Access Compliance Report

(Curb Ramps)

Intersection ID: 43655	Main Street: HUNTINGTON_MEADOW_LN	Cross Street: KELLINGTON_CT	Location: NE
ADA ID: E427D3B28203	Ramp Type: PerpDiag	Initial Pass/Fail: Fail	Overall Compliance: No
Codes/Mitigation Info/Possible Solution		Field Measurements/Component Compliance	
Severity Score: 21.25

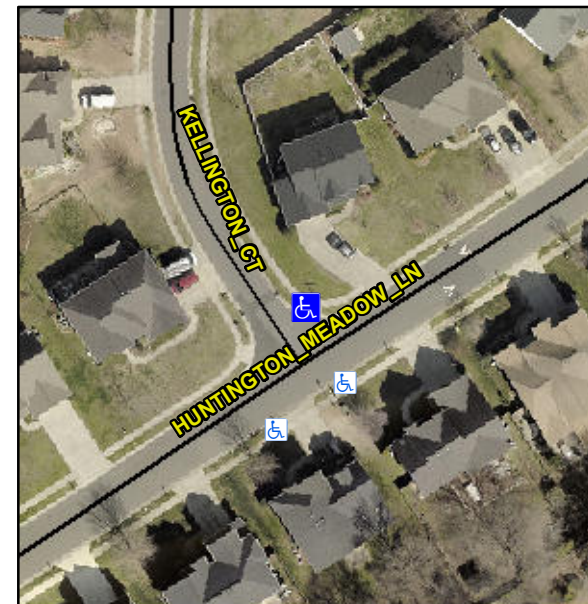
R304.5.1, R304.2.2

Compliance	Description	Data	Compliance	Description	Data
N/A	Ramp Length (in)	48.0	No	Ramp Slope (%)	10.2
No	Ramp Width (in)	41.0	Yes	Ramp XSlope (%)	1.0
N/A	Flare Type LT	N/A	N/A	Flare Type RT	N/A
N/A	Flare Slope LT (%)	N/A	N/A	Flare Slope RT (%)	N/A
N/A	Flare Traversable LT?	N/A	N/A	Flare Traversable RT?	N/A
N/A	Landing Length (in)	N/A	N/A	DWS Provided?	N/A
N/A	Landing Width (in)	N/A	N/A	DWS Contrast?	N/A
N/A	Landing Slope (%)	N/A	N/A	DWS Length (in)	N/A
N/A	Landing X Slope (%)	N/A	N/A	DWS Full Width?	N/A
N/A	Landing Curb? (Y/N)	N/A	N/A	DWS Offset (in)	N/A
N/A	Shared Landing?	N/A			
N/A	Gutter Ponding?	N/A	N/A	Gutter Slope (%)	N/A
N/A	Gutter Lip Ht (in)	N/A	N/A	Gutter X Slope (%)	N/A
N/A	Painted X Walk1?	No	N/A	Painted X Walk2?	No
	X Walk 1 Direction	To SW		X Walk 2 Direction	To S
N/A	X Walk 1 Width (in)	N/A	N/A	X Walk 2 Width (in)	N/A
	X Walk 1 Slope (%)	3.2		X Walk 2 Slope (%)	3.3
	X Walk 1 X Slope (%)	1.7		X Walk 2 X Slope (%)	0.6

Remove & Replace Curb Ramp With Two New Directional Ramps or Equivalent.
